Application ref: 2023/2470/PRE
Contact: Ewan Campbell
Tel: 020 7974
Email: Ewan.Campbell@camden.gov.uk
Date: 17/08/2023

Pre-application Householder Development Pre-application Advice Issued

**63 Netherhall Gardens
London
NW3 5RE**

Proposal: Demolish existing extension and erection of new part width single storey rear extension with green roof and roof lantern, basement extension with rear and front lightwell, alteration to access to rear garden.

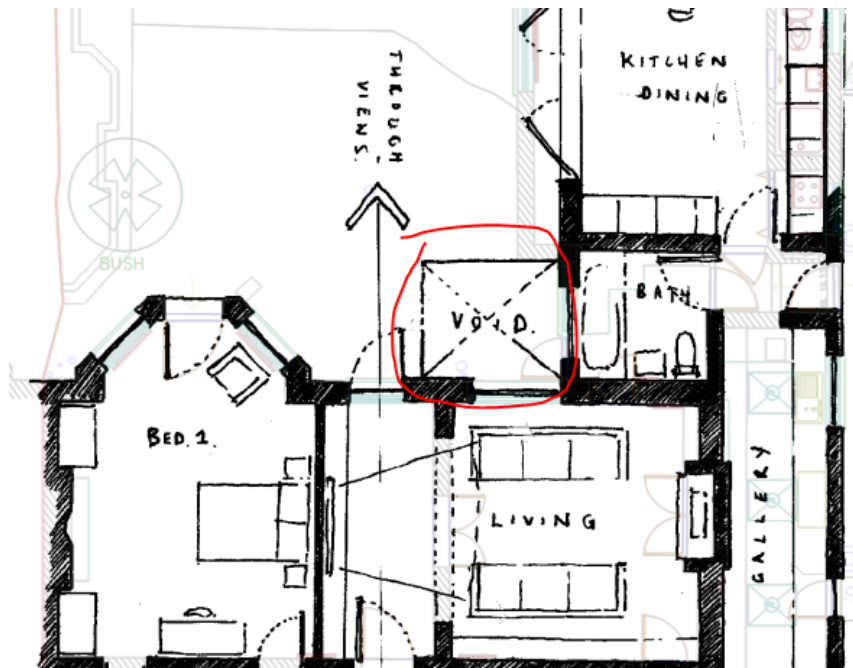
The principle of a lightwell at the rear of the property is supported but its size and appearance must be altered due to its excessive depth and proximity to the existing rear bay feature. It is understood that there was previously a lightwell in this location and as such a new lightwell with similar dimensions to the submitted sketch (see below) may be acceptable, subject to its detailed design and siting.

The rear lightwell should be glazed and not open to ensure that any impact on design is mitigated.
